## Addendum #2

Date Owner Property Number **BHDA Project Number** Mon, 11 Aug 2025 502-2036 2429 Project Designation **Project Address** Smithfield 19 & approx. 801 East Upper Canyon Road Smithfield UT North Stake Smithfield, Utah **Copies To** Brian Childs......Church Project Manager Mike Felix ......Church Facilities Manager **Invited Bidders** Architect's Consultants **Bid Opening Time Bid Opening Location** Tue, 19 Aug 2025, at 2:00 pm via ConsLog: https://conslog.daily.co/pre bid 7860 1. Changes to Prior Addenda 1.01. None. 2. Changes to Procurement and Contracting Requirements 2.01. None. 3. Changes to Specifications 3.01. None. 4. Changes to Drawings

Smithfield 19
Smithfield UT North Stake
801 East Upper Canyon Road (6400 North), Smithfield, Utah
41.846455,-111.809826

#### 4.02. Sheet C503 Site Details

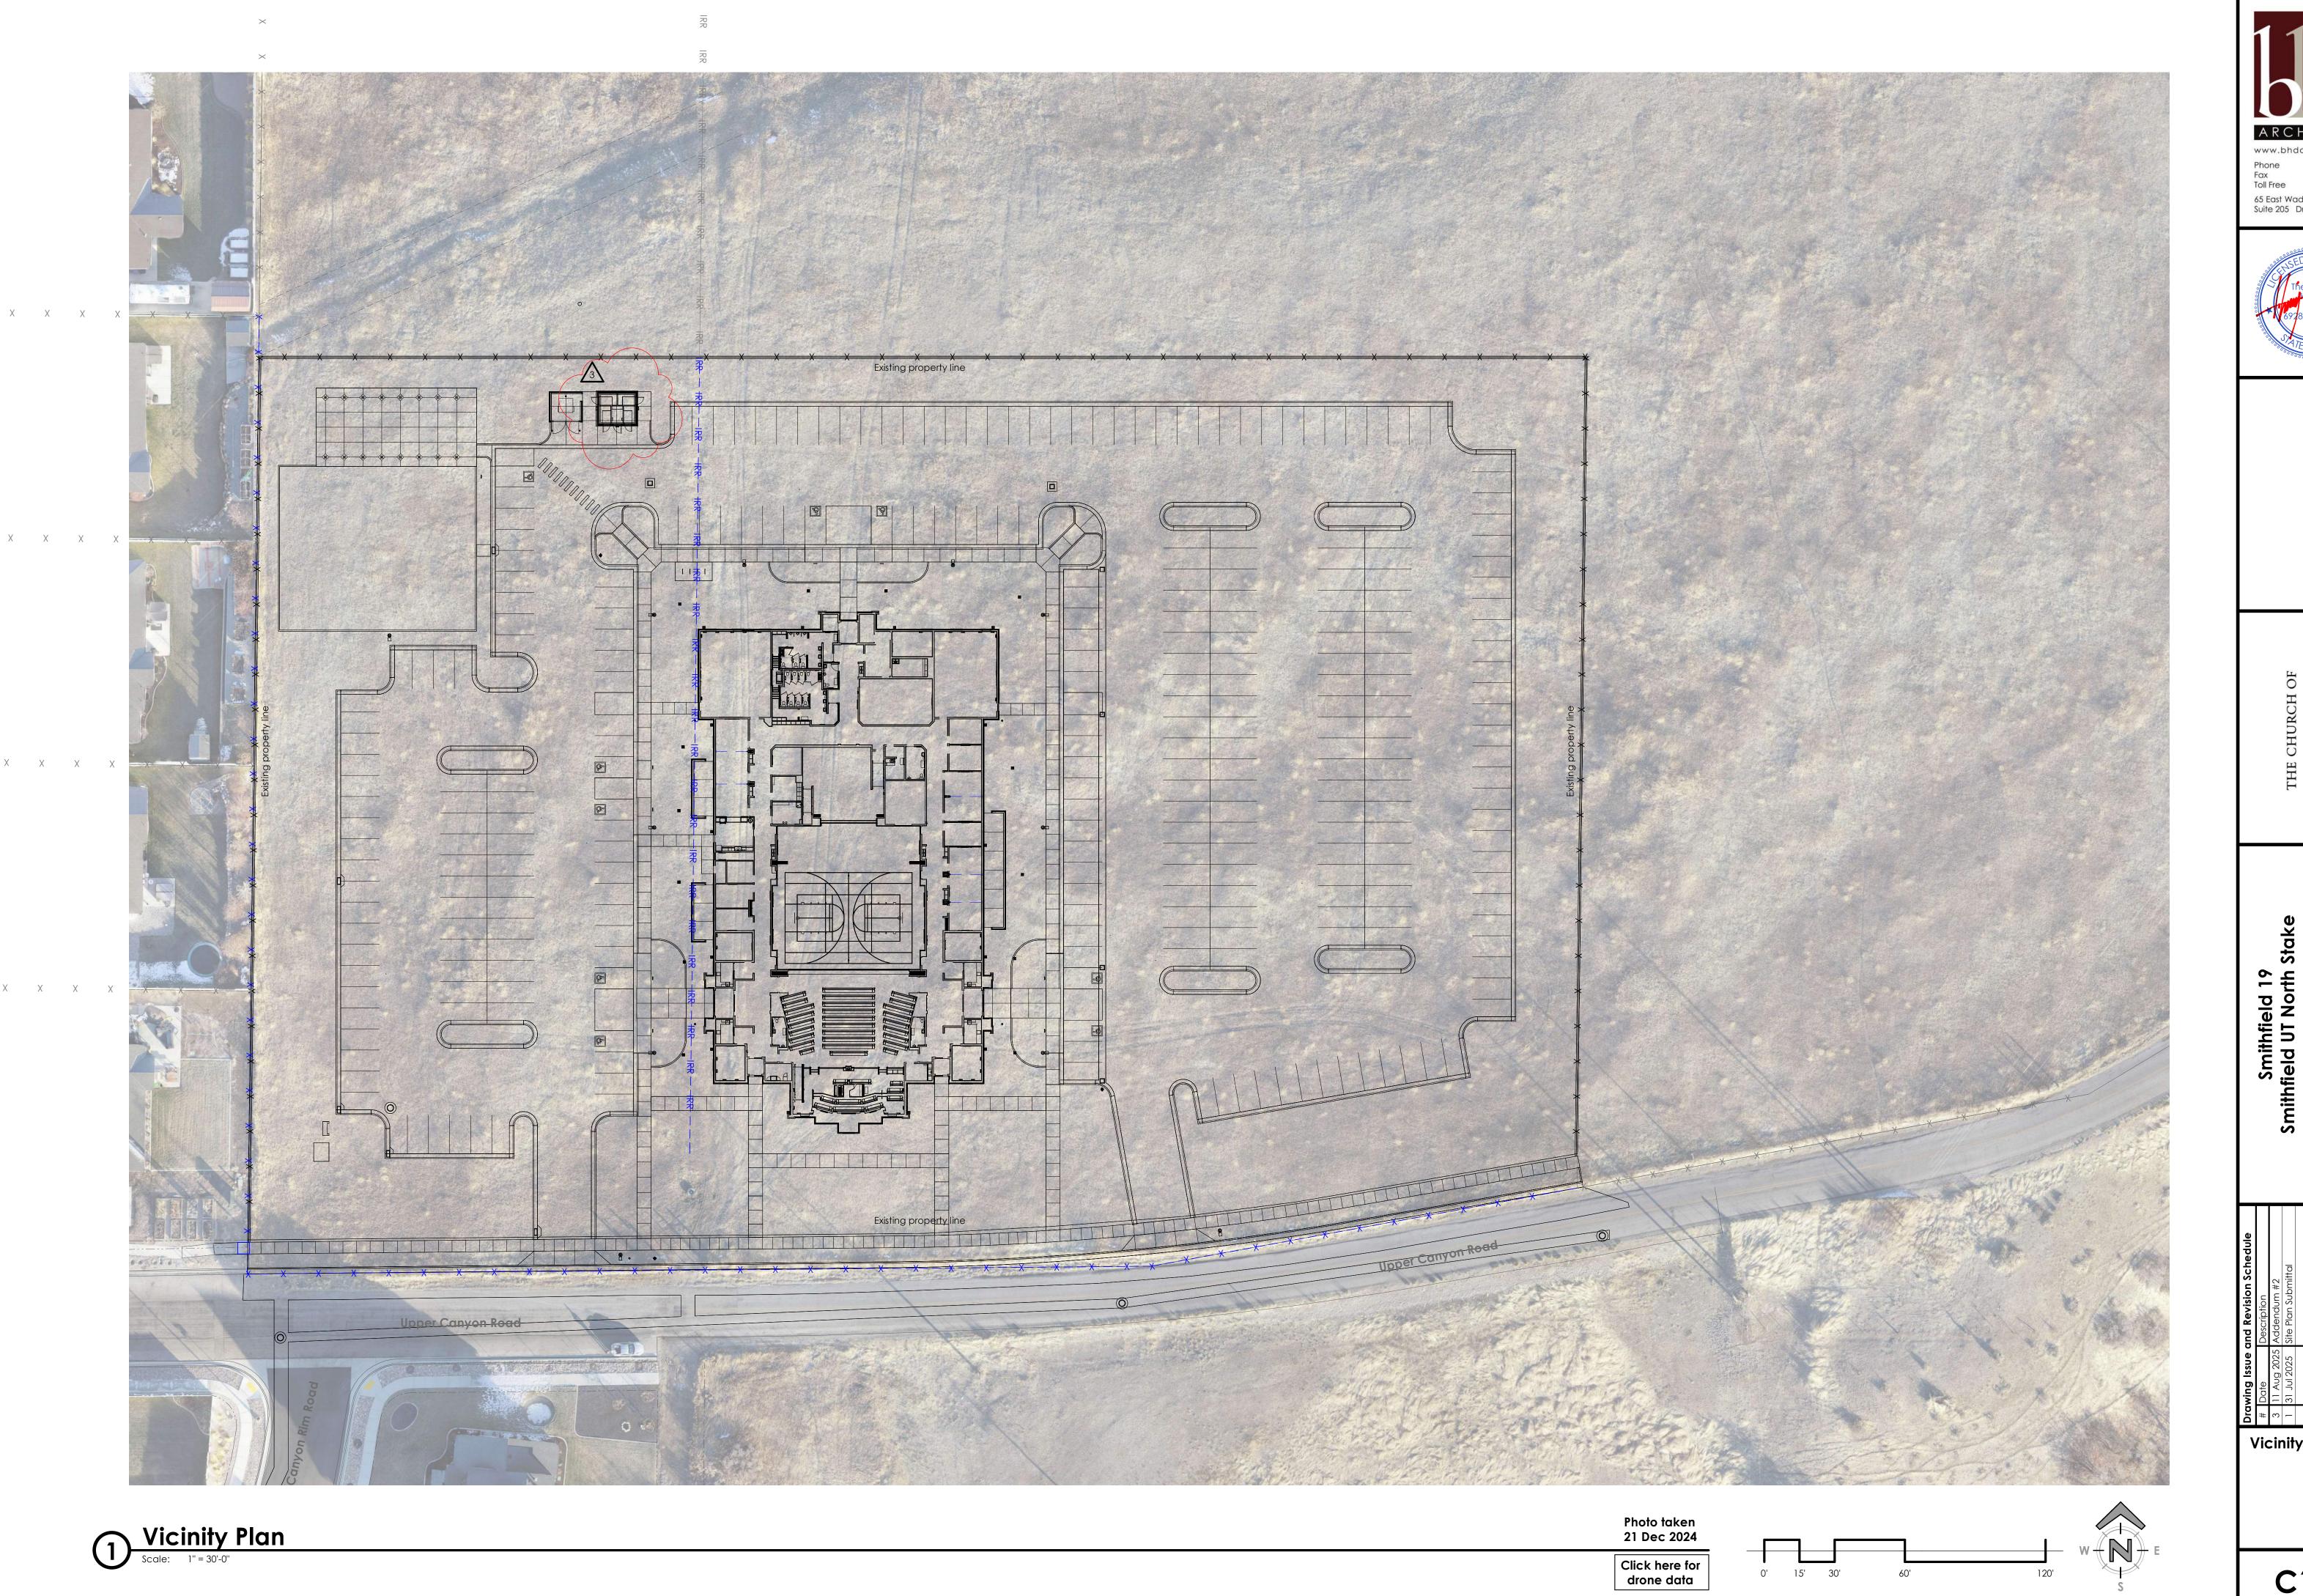
- A. Replace this Sheet with the attached revised Sheet.
  - 1. An old sheet was inadvertently included in the bid documents. This corrects that error with an up-to-date sheet.

### 4.01. Sheet C102 Vicinity Site Plan

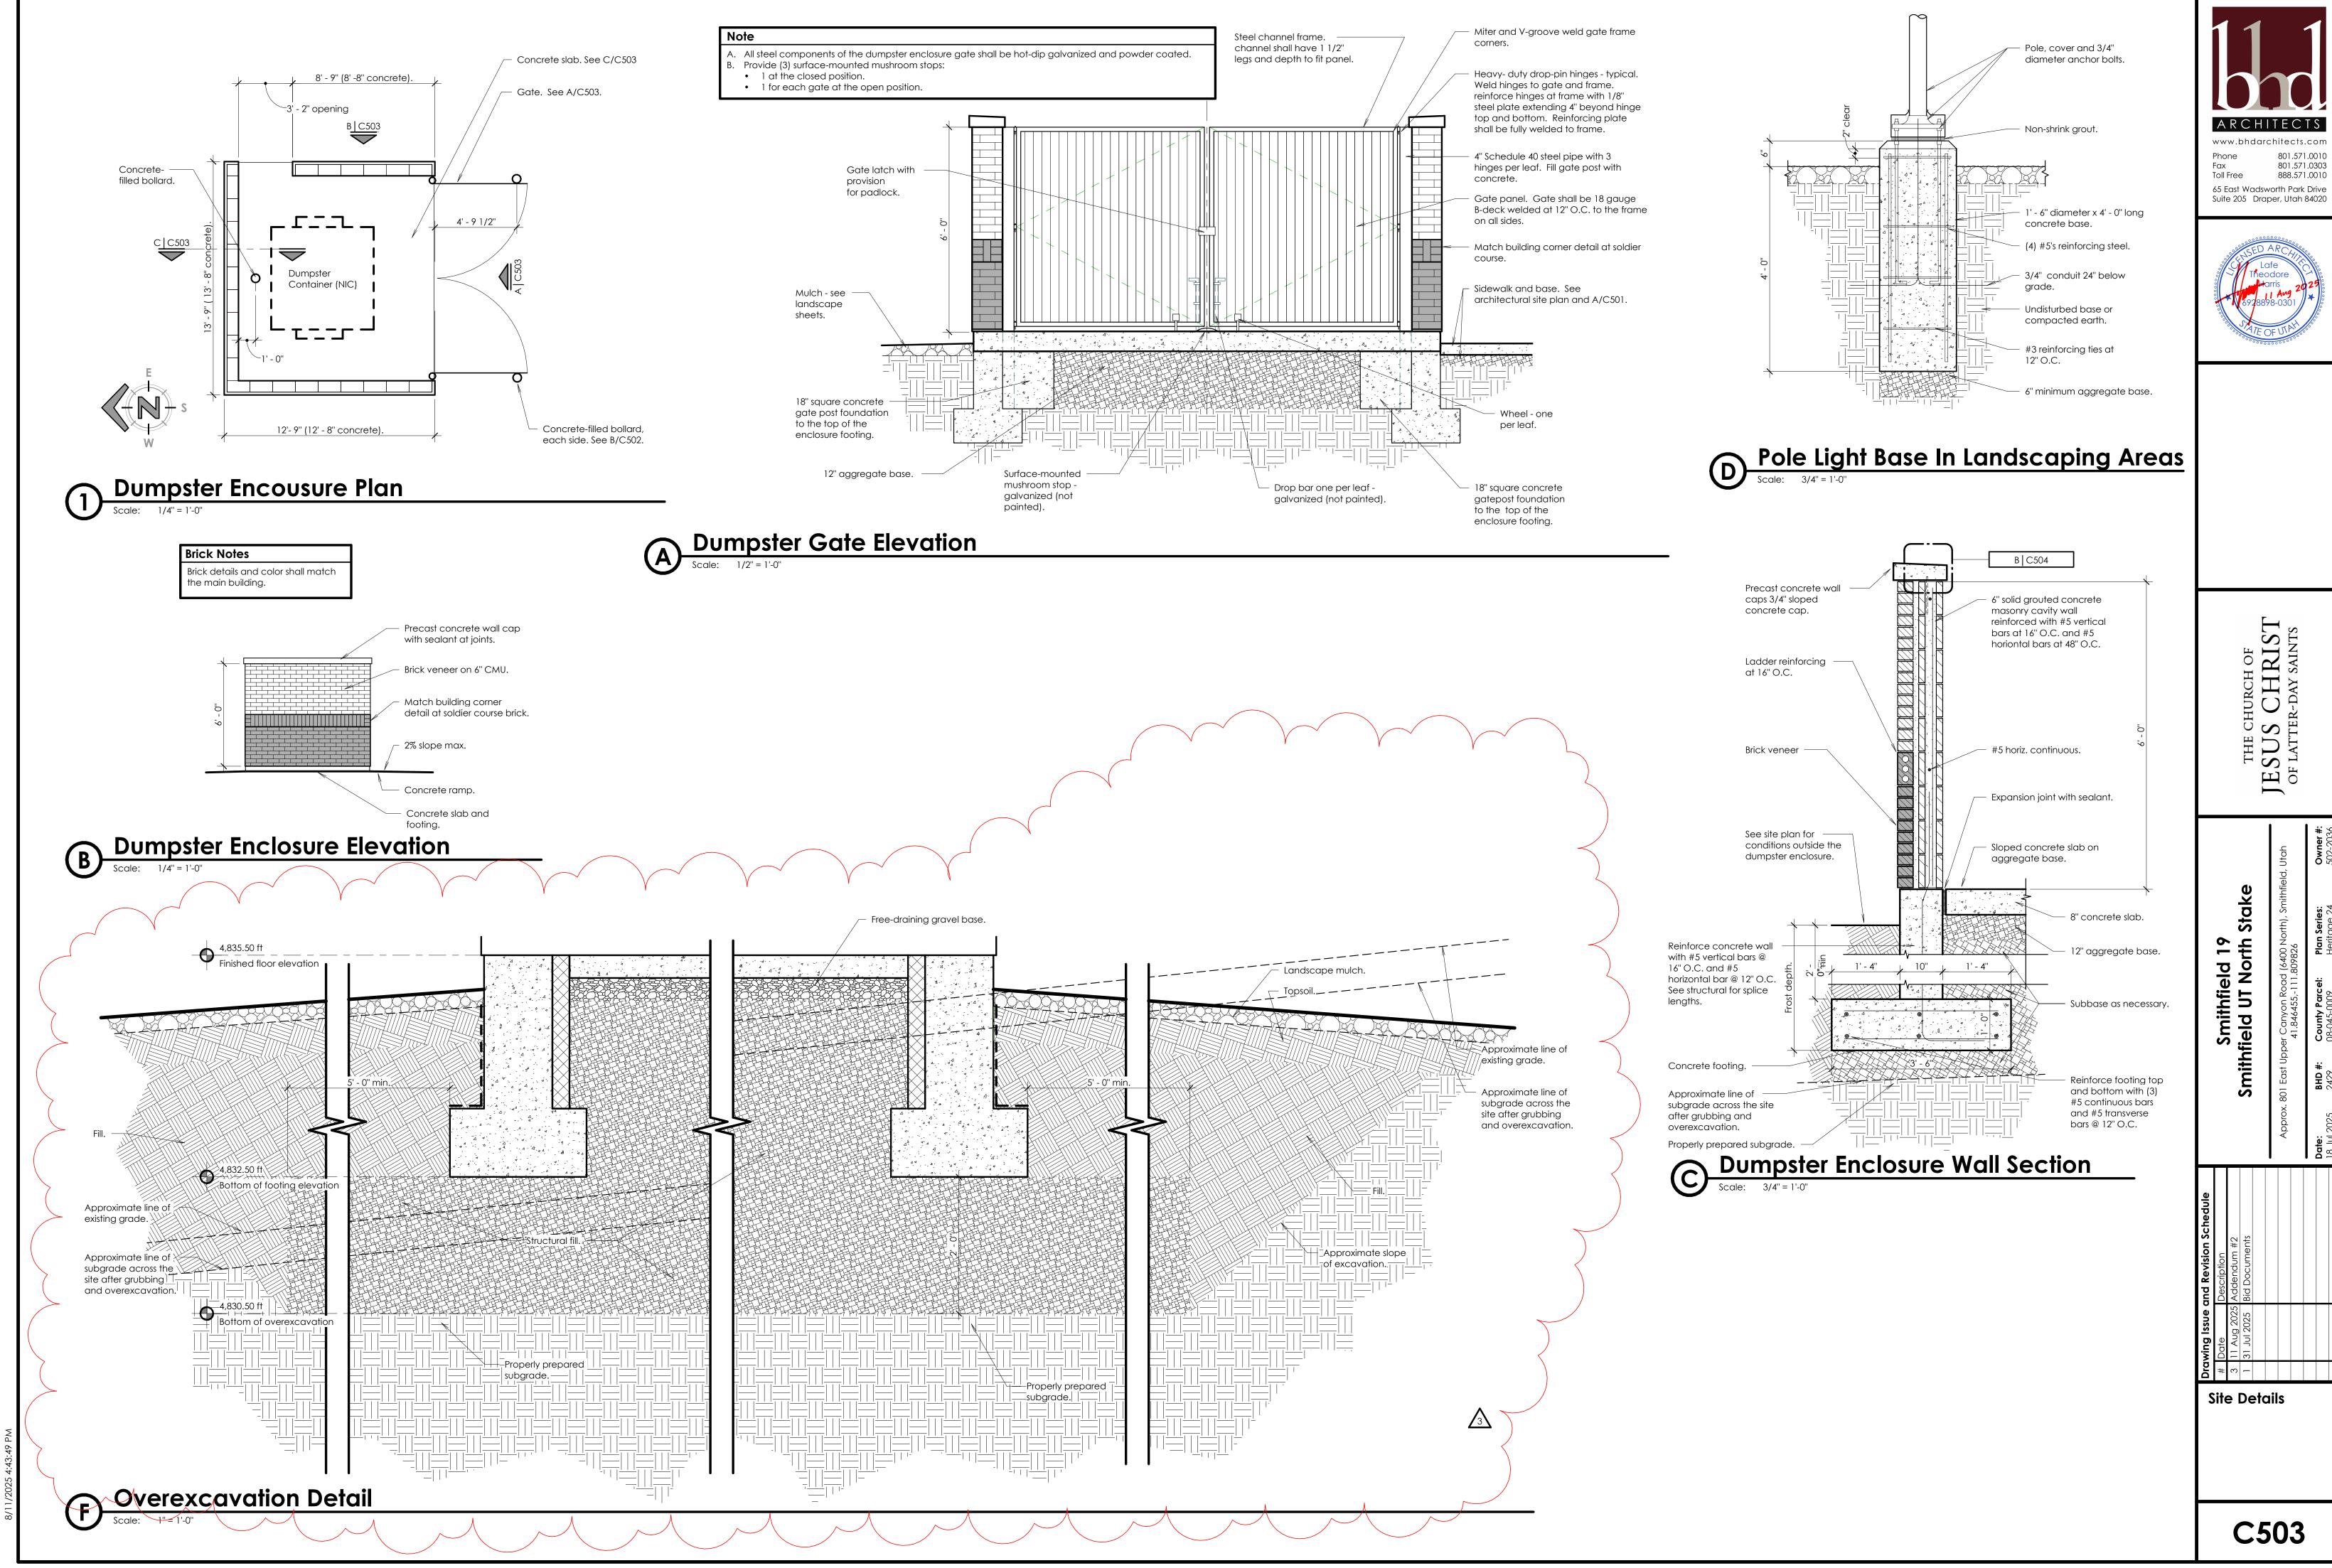
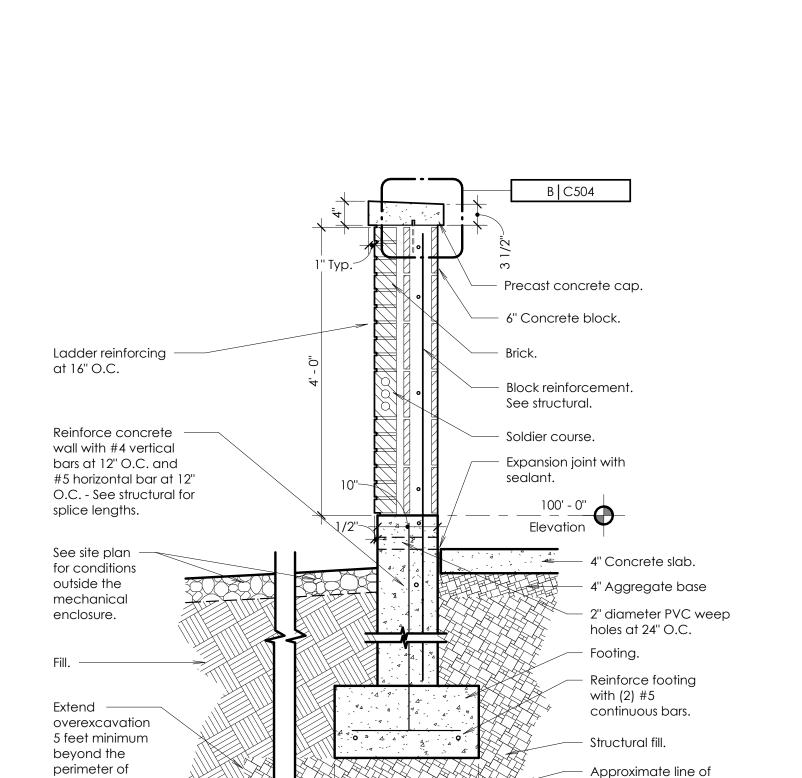
- A. Replace this Sheet with the attached revised Sheet.
  - 1. The storage building was inadvertently missing from this sheet in the bid documents. This corrects that error.

### 4.03. Sheet C504 Site Details

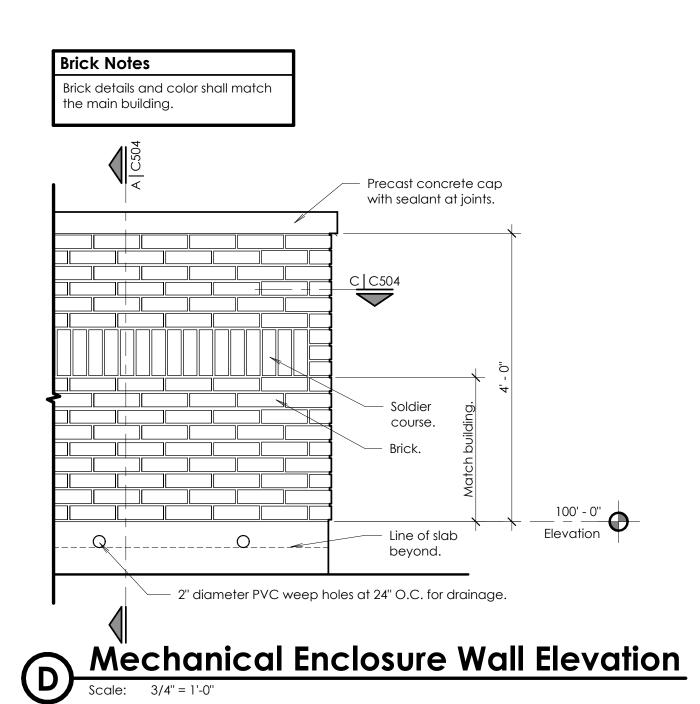
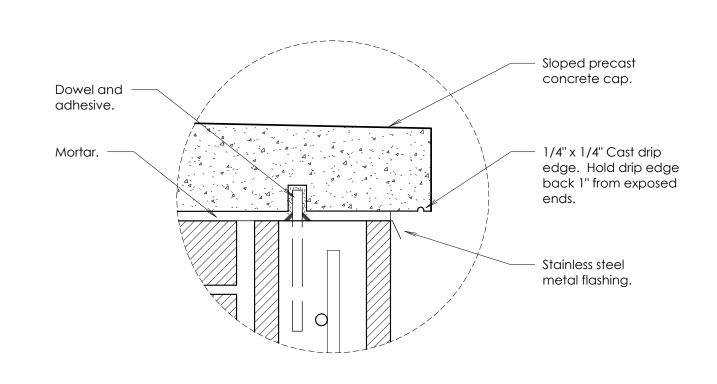
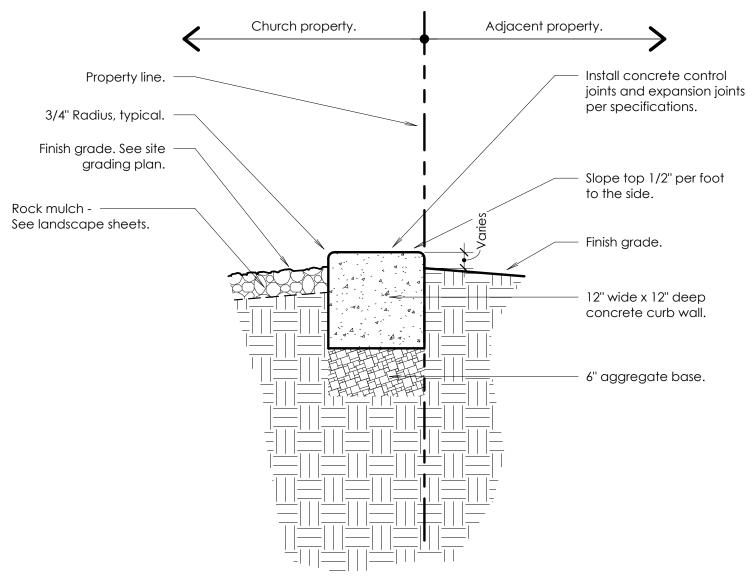
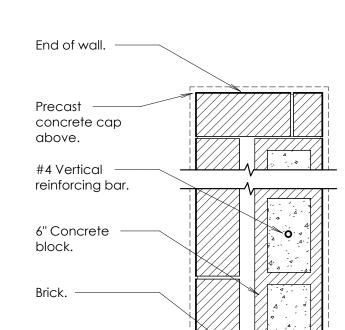
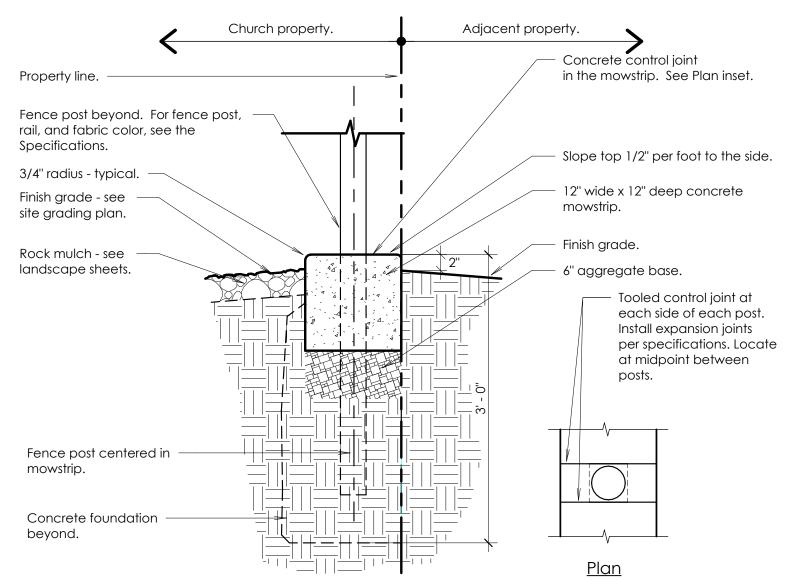
- A. Replace this Sheet with the attached revised Sheet.
  - 1. An old sheet was inadvertently included in the bid documents. This corrects that error with an up-to-date sheet.
